IDAP REPORT

Property:	148 Homebush Road STRATHFIELD Lot 5 in DP 666172 DA2021.207
Proposal:	Demolition of existing structures and Torrens title subdivision of one (1) lot into two (2) lots with a battle-axe access configuration.
Applicant:	Platform Five Design Pty Ltd
Owner:	N G D'Alessandro & J R Nader
Date of lodgement:	18 August 2021
Notification period:	30 August – 14 September 2021
Submissions received:	Nil
Assessment officer:	L Gibson
Estimated cost of works:	\$50,000.00
Zoning:	R2-Low Density Residential - SLEP 2012
Heritage:	N/A
Flood affected:	No
Is a Clause 4.6 Variation Proposed:	No
RECOMMENDATION OF OFFICER:	REFUSAL

Figure 3: Aerial imagery of subject site (Source: Nearmaps).

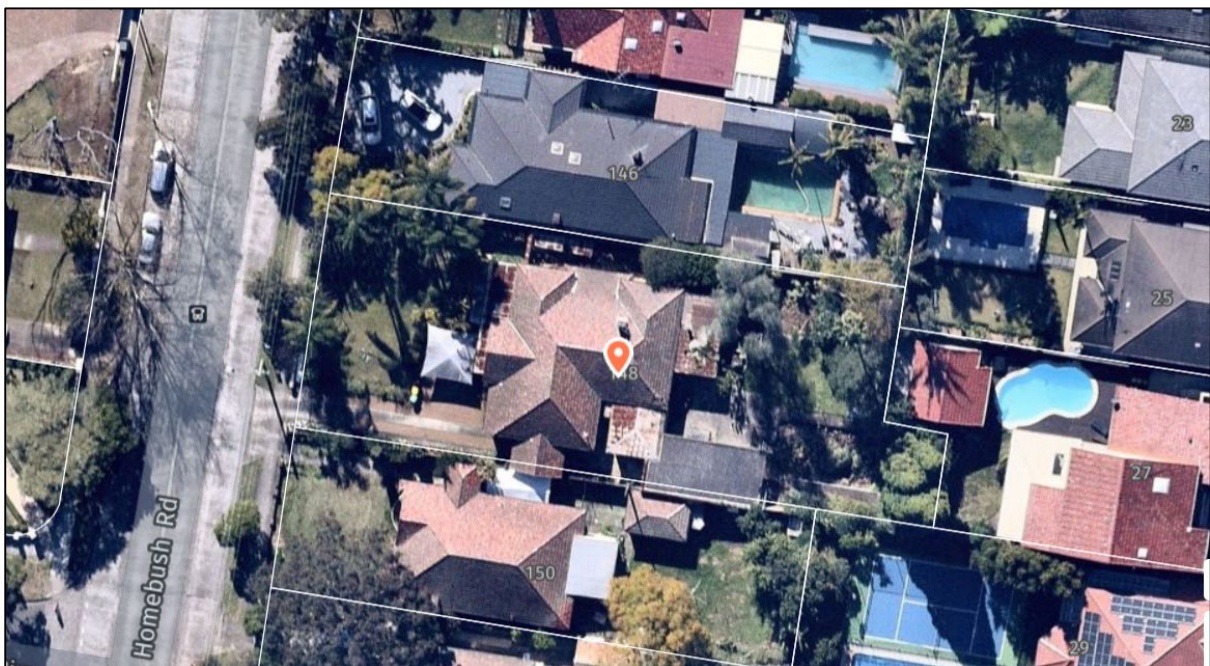
The proposal fails to consider the retention and protection of trees as part of this application. Based on the latest aerial data information available (refer to Neamap figure below), it appears that a number of mature trees are located both in and around the site. Conversely, the submitted survey plan and proposed subdivision plans fail to include this level of information with a number of mature trees not shown on the plan.

Figure 4: Submitted Survey Plan

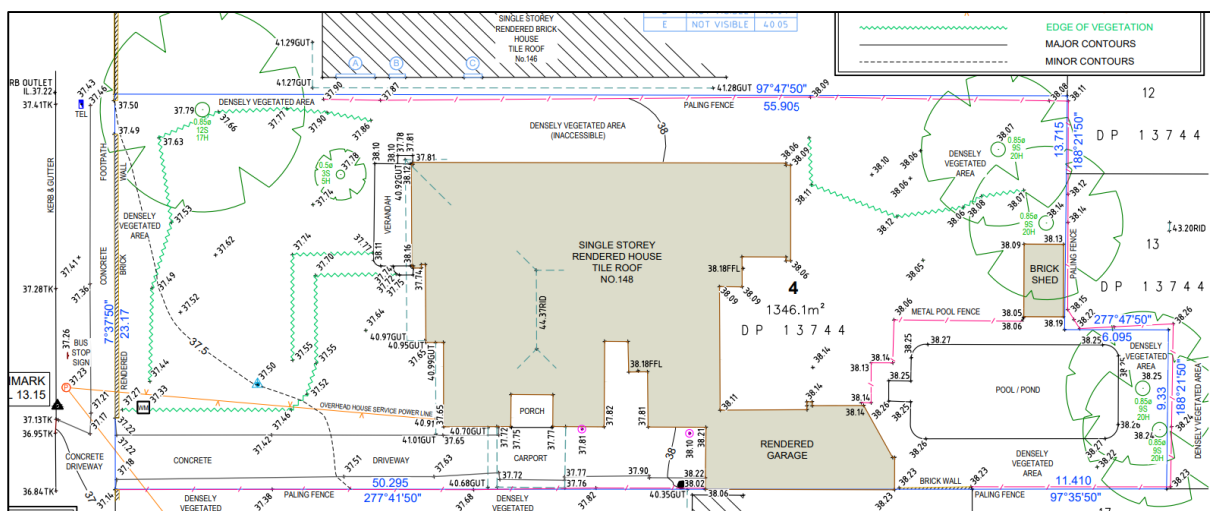
The application not only fails to accurately document the trees both in and around the site but has also failed to provide any justification for tree removal to accommodate the proposed development. This includes proposed provision of a second driveway crossing from Homebush Road which appear to result in adverse tree impacts. Accordingly, the proposal fails to satisfy the aims and objectives outlined within the SEPP and is unable to be supported.

Figure 4: Subdivision pattern of surrounding context (subject site in yellow) also showing heritage listed property at 123-127 Homebush Road spanned across three (3) separate Torrens Title Lots (outlined in red).

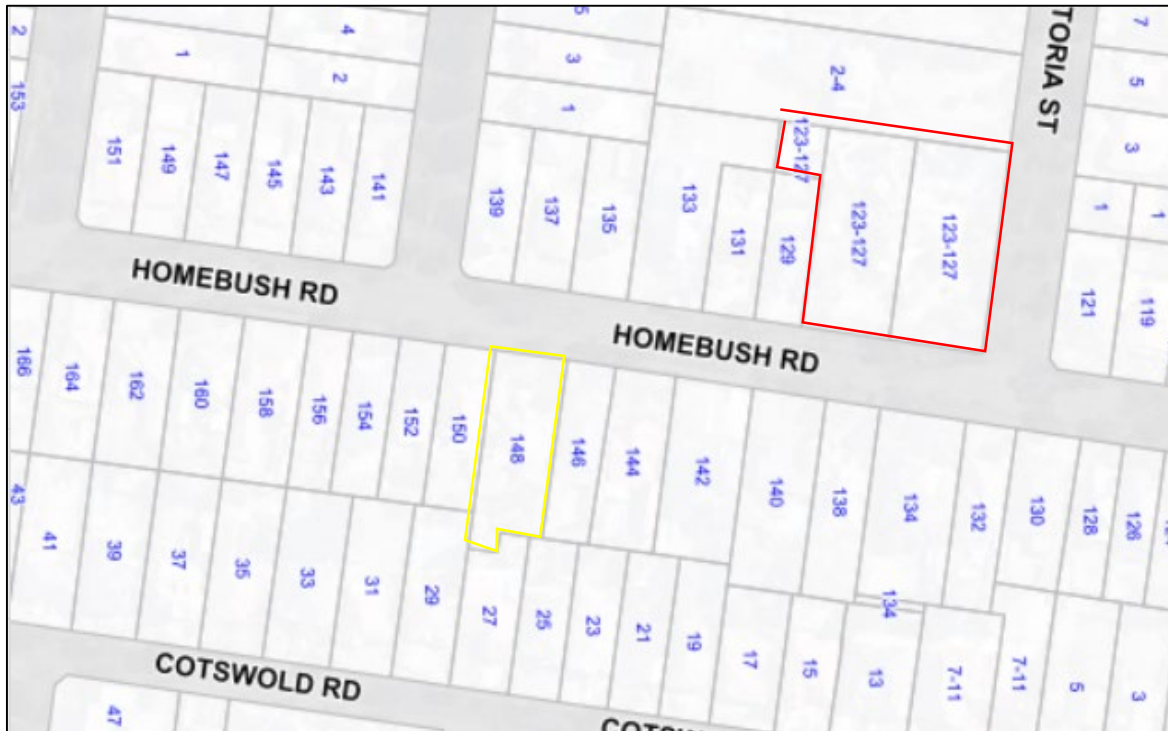
With regard to Clause 3, aerial imagery of the surrounding subdivision pattern is provided in Figure 4 below. Based on the current subdivision pattern of the area (as defined in the SCDCP as ten allotments on either side of the subject site and corresponding number of allotments directly opposite the subject site) the figure demonstrates that the subdivision pattern is relatively uniform. Lots are predominantly regular in shape with similar depths and frontage widths. Whilst the corner property at 123-127 displays an irregular lot size, the property is a heritage listed site containing only one (1) single dwelling house across three (3) separate lots. The proposed subdivision plan will result in lots which are severely inconsistent and thus incompatible with the prevailing subdivision pattern in the immediate vicinity and is therefore not supported in this regard.

Figure 5: Indicative building footprint plans of subject site.

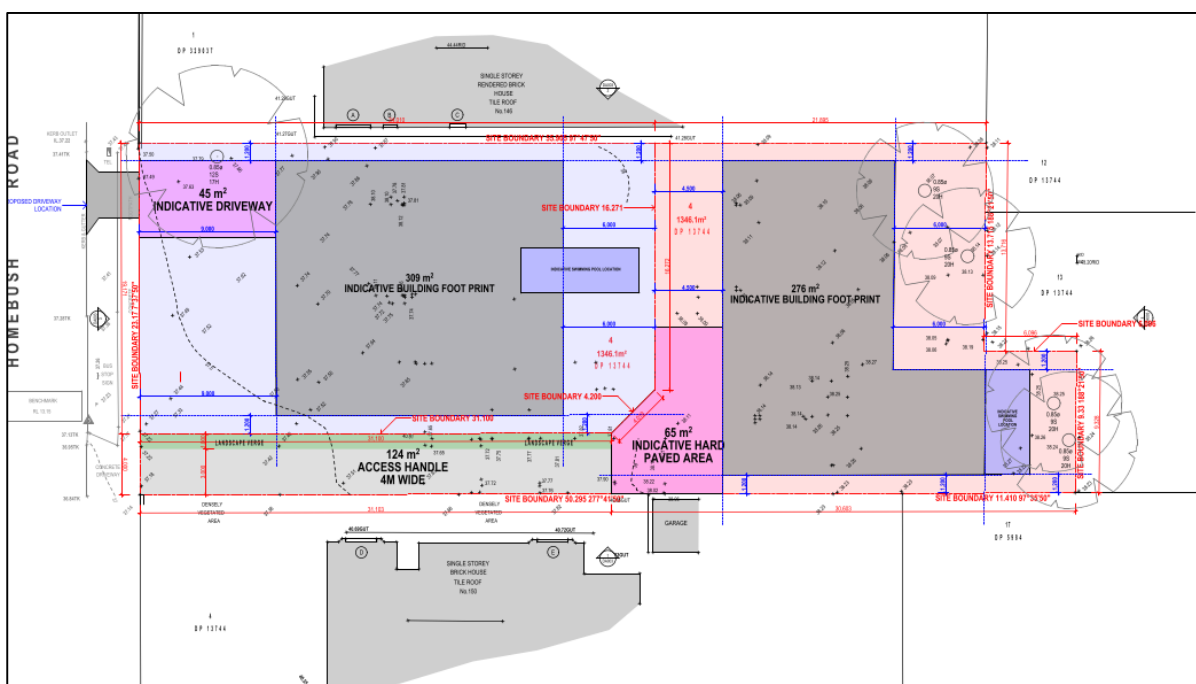
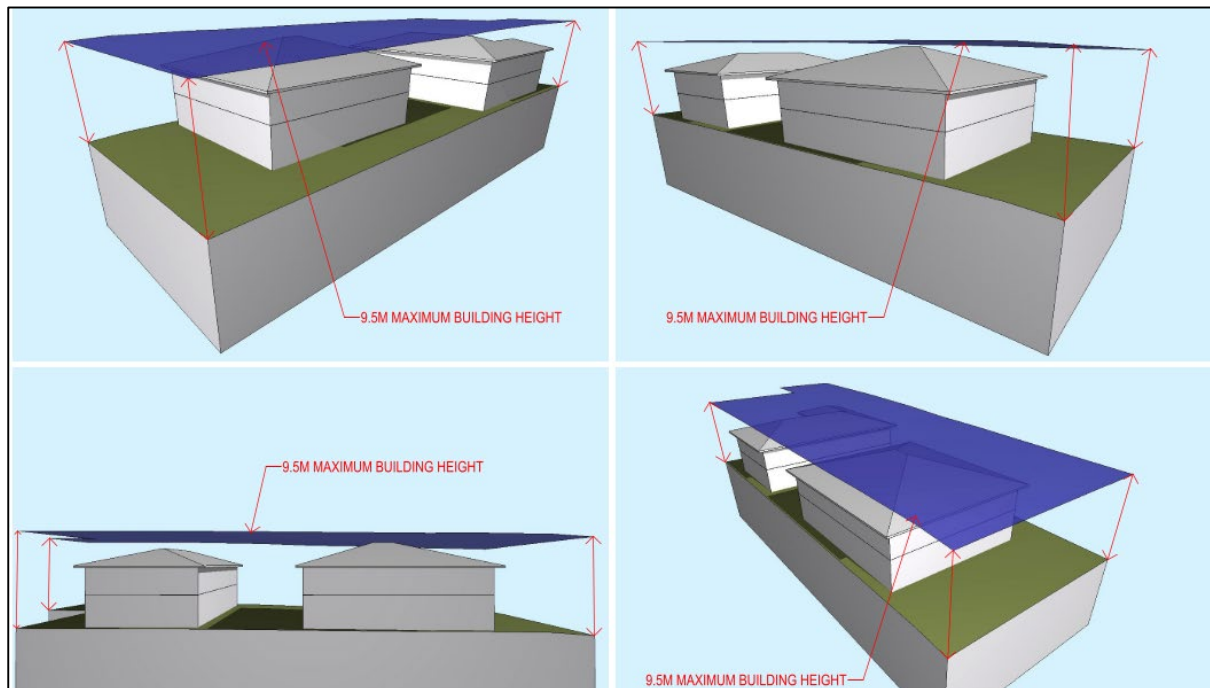
With regard to Clause 4, the site has an east-west orientation. Accordingly, overshadowing to southern adjoining properties is unavoidable. Whilst shadow diagrams have not been submitted as part of this application, it is evident that the southern adjoining property at 140 Homebush Road will be cast in shadow throughout the entirety of the day due to the proposed subdivision resulting in two (2) separate dwelling houses. Figures 5 and 6 below demonstrates the indicative building layout plan and building heights of the new dwelling developments envisaged for the site. The dwellings appear to be two (2) storey in height sitting just below the 9.5m building height limit. The property at 140 Homebush Road will therefore be severely impacted by the proposed development receiving minimal solar access throughout the day.

Further, whilst to a lesser extent, it appears that the eastern and south-eastern adjoining properties at 27 and 29 Cotswold Road may also be affected by the proposed development. Solar access to these properties is already compromised due to their east-west orientation as

well as existing two (2) storey development located north of these properties. The proposed subdivision development and likely redevelopment of the subsequent lots will further reduce solar access received to these properties in the afternoon hours of the day thus compromising opportunities for solar access to these properties. The proposal fails to demonstrate that a reasonable development of the new lots can facilitate a contextually appropriate design and planning outcome that enables equitable and sufficient amenity for adjoining residents (as well as future residents of any future dwelling development on lot 2). Accordingly, the proposal is unable to be supported in this regard.
